Department of Energy
Washington, DC 20585

PROPOSED CHANGES TO THE
NEVADA NUCLEAR WASTE STORAGE INVESTIGATIONS PROJECT
EXPLORATORY SHAFT FACILITY

BACKGROUND PAPER
FOR THE
U.S. NUCLEAR REGULATORY COMMISSION
AND
THE STATE OF NEVADA
AGENCY FOR NUCLEAR PROJECTS
NUCLEAR WASTE PROJECT OFFICE

MARCH 1987

Figure 6. Comparative Illustration of the Final EA Versus the Proposed Main Test Level Arrangement.

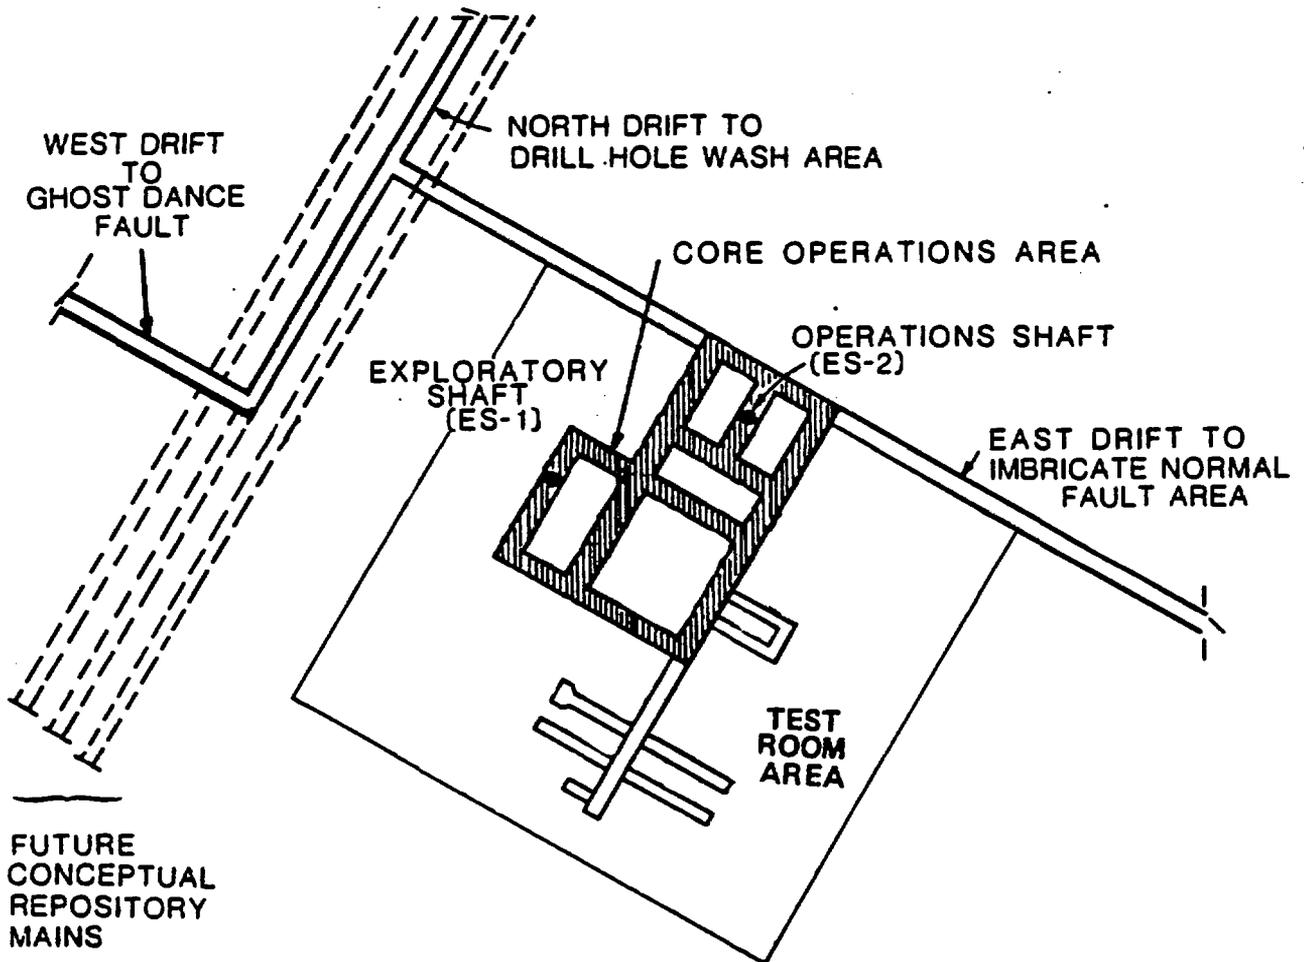
As stated earlier, the main test level concept proposed in the EA was a compact configuration of drifts and test areas designed to meet preliminary test requirements and provide a concept that could be built with a modest expenditure. The NNWSI Project proposes to reconfigure the main test level to accommodate the current test requirements and provide facilities to support the additional drifting proposed. The proposed layout would also minimize the impact of construction of the drifts on concurrent main test level testing, ensure compatibility with the repository conceptual design, add support facilities, and provide flexibility to the facility. The resultant layout increases drift length in the main test level area from 1500 feet to 4000 feet, as shown in Figure 6. The test room areas, shown in Figure 6, are only conceptual illustrations which will, most likely, evolve into a different configuration as the design process evolves.

The addition of three long exploratory drifts imposed new requirements on the main test level area. The layout of the area was modified to utilize the second shaft as an operations shaft for removal of muck and transport of men and materials involved in the construction of the long drifts. In order to provide for concurrent testing and construction activities, the test area layout was reconfigured to allow separation of mining and muck removal activities from the scientific investigation ongoing in ES-1 and the test areas of the main test level.

Figure 8. Proposed location of facilities utilized during Exploratory Shaft Facility construction and testing.

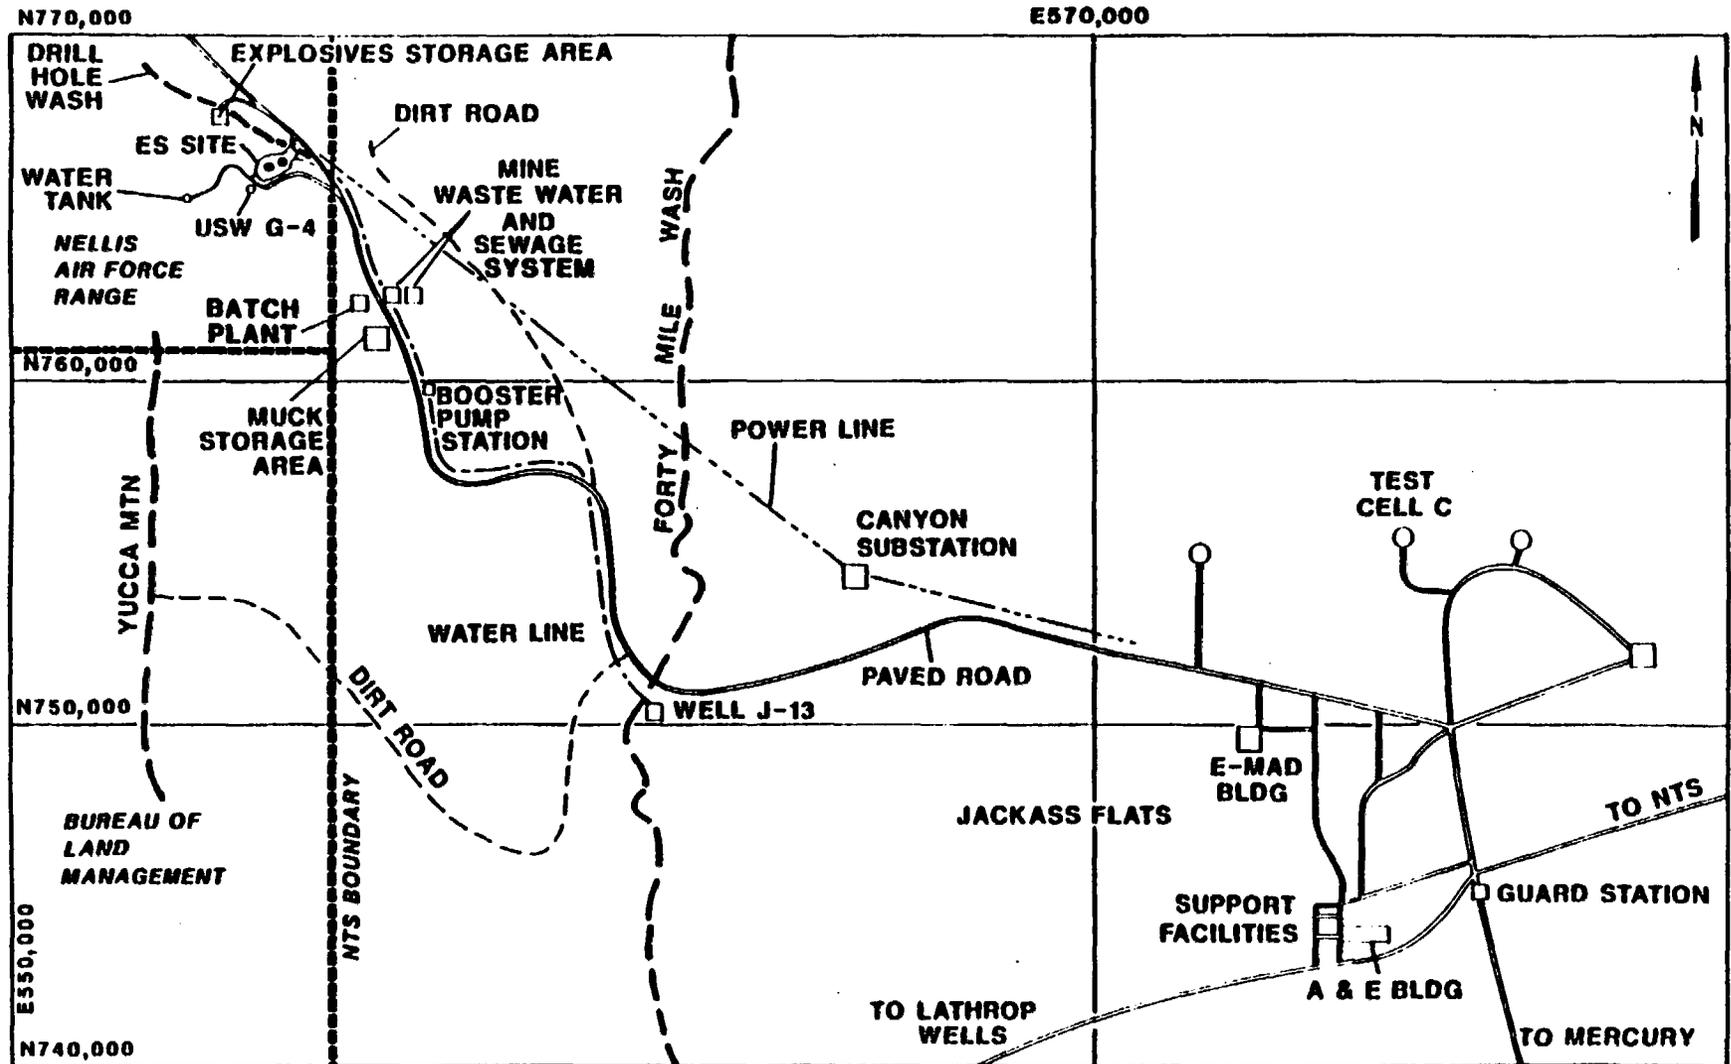
To assess the impact of the proposed revisions to the ESF design, construction approach, and schedule on the conclusions reached in the EA, a preliminary evaluation was conducted between the EA (as the reference case) and the proposed changes in each of the technical areas listed in the EA to assess the incremental impacts of those proposed changes. The environmental impact analyses of the EA presented a range of values using a reasonable but conservative approach to impact evaluation, and this same approach was applied in the preliminary analysis of the proposed revision. The results of the EA analysis and the preliminary analysis were compared to determine whether the revised design, construction approach, and schedule would result in impacts not bounded by the range of impacts as reported in the EA. It was determined that the proposed changes will result in reductions in impact in some areas, no change in others, and some minor additional impacts to the environment from the revised and expanded construction requirements. The conclusion of the preliminary evaluation is that increased impacts are minimal, do not contribute to the degradation of the environment, and are within the impacts analyzed in the EA. The results of this preliminary evaluation and comparison are summarized in the following sections for each of 12 separate impact areas. Figure 8 shows the facilities which were considered in the evaluation.
